Access Compliance Report

Public Rights-of-Way

Intersection ID: 10745	Main Street: E_35TH_ST	Cross Street: HOLT_ST	Location: SW
ADA ID: 186B508BD167	Ramp Type: Perp	Initial Pass/Fail: Fail	Overall Compliance: No
Codes/Mitigation Info/Possible Solution		Field Measurements/Component Compliance

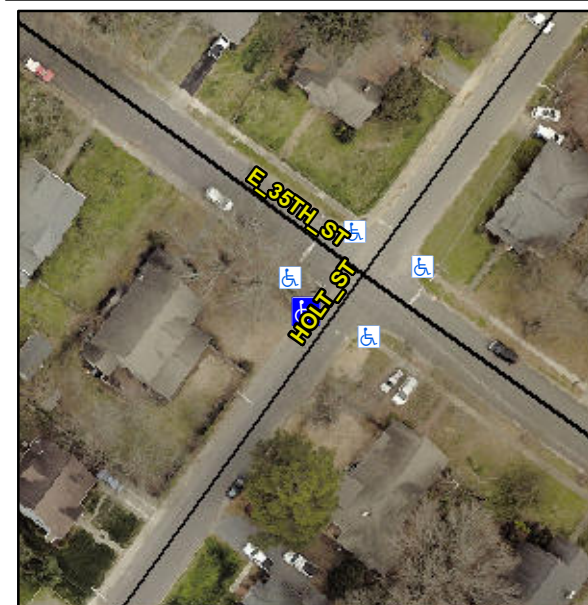
Not Found, R304.2.2, R304.5.3

Compliance	Description	Data	Compliance	Description	Data
N/A	Ramp Length (in)	49.0	No	Ramp Slope (%)	11.9
Yes	Ramp Width (in)	48.0	No	Ramp XSlope (%)	3.0
N/A	Flare Type LT	N/A	N/A	Flare Type RT	N/A
N/A	Flare Slope LT (%)	N/A	N/A	Flare Slope RT (%)	N/A
N/A	Flare Traversable LT?	N/A	N/A	Flare Traversable RT?	N/A
N/A	Landing Length (in)	N/A	N/A	DWS Provided?	N/A
N/A	Landing Width (in)	N/A	N/A	DWS Contrast?	N/A
N/A	Landing Slope (%)	N/A	N/A	DWS Length (in)	N/A
N/A	Landing X Slope (%)	N/A	N/A	DWS Full Width?	N/A
N/A	Landing Curb? (Y/N)	N/A	N/A	DWS Offset (in)	N/A
N/A	Shared Landing?	N/A			
N/A	Gutter Ponding?	N/A	N/A	Gutter Slope (%)	N/A
N/A	Gutter Lip Ht (in)	N/A	N/A	Gutter X Slope (%)	N/A
N/A	Painted X Walk1?	No	N/A	Painted X Walk2?	N/A
	X Walk 1 Direction	To SE		X Walk 2 Direction	N/A
N/A	X Walk 1 Width (in)	N/A	N/A	X Walk 2 Width (in)	N/A
	X Walk 1 Slope (%)	4.7		X Walk 2 Slope (%)	N/A
	X Walk 1 X Slope (%)	0.4		X Walk 2 X Slope (%)	N/A

Remove & Replace Entire Ramp.
